FORM APPROVED
OMB NO. 1004-0137
Expires: January 31, 2018**SUNDRY NOTICES AND REPORTS ON WELLS**
*Do not use this form for proposals to drill or to re-enter an abandoned well. Use form 3160-3 (APD) for such proposals.*5. Lease Serial No.
NMNM27506

8. Well Name and No.
SD EA 29 FED COM P8 11H /9. API Well No.
30-025-43270-00-X110. Field and Pool or Exploratory Area
WC025G06S263319P-BONE SPRING11. County or Parish, State
LEA COUNTY, NM**SUBMIT IN TRIPLICATE - Other instructions on page 2**

CHEVRON respectfully requests the ability to change the BOPE rating for the subject well, from a 5M system to a 10M system while drilling the production sections that penetrate the Wolfcamp formation. (All intermediate sections, which TD in the Bone Spring, will have the previously submitted 5M system setup).

10M Choke Manifold SCHEMATIC

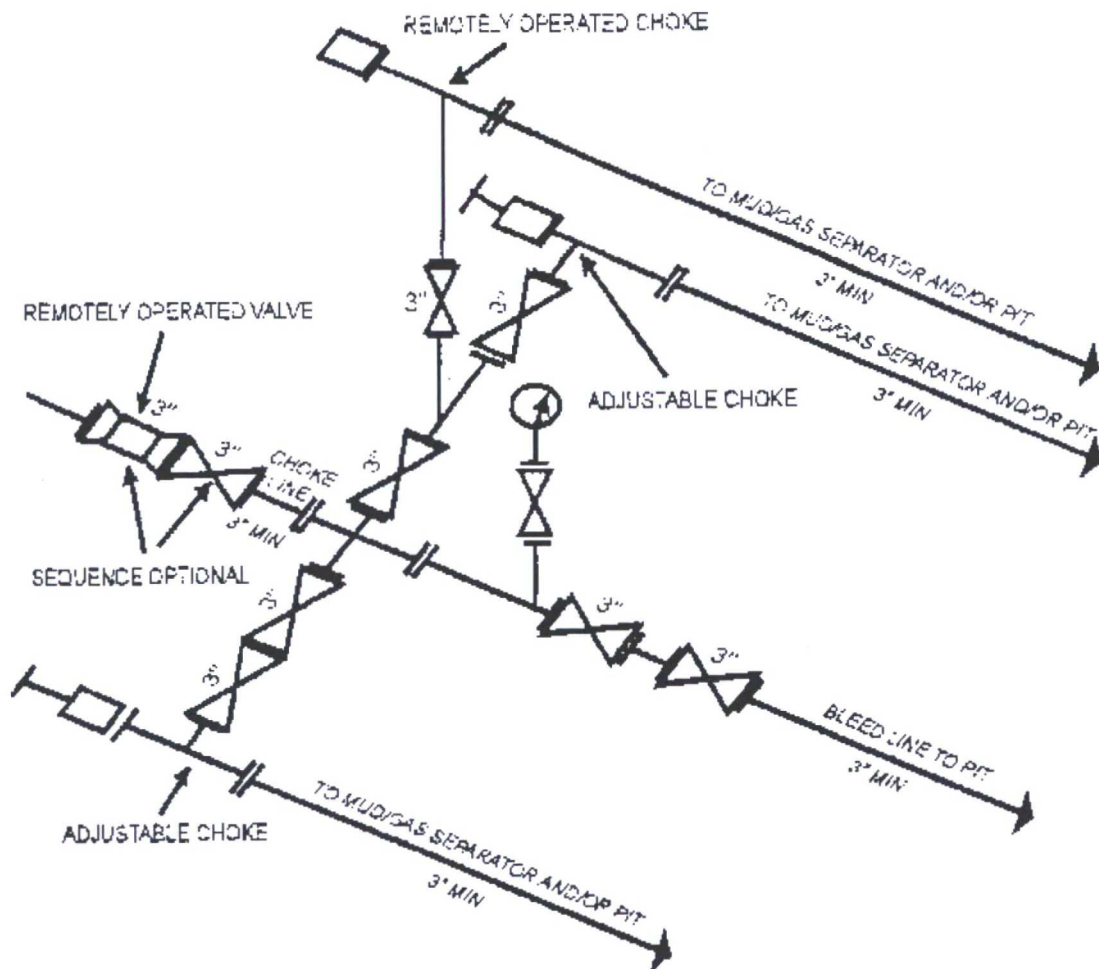
*All equipment will be 5M as per the original submittal, but the annular will be 10M, as well as the necessary upgrades to the choke manifold. (Upgrade 2" choke lines to 3" with a third choke).

Please find attached, the 10M BOP choke schematic.
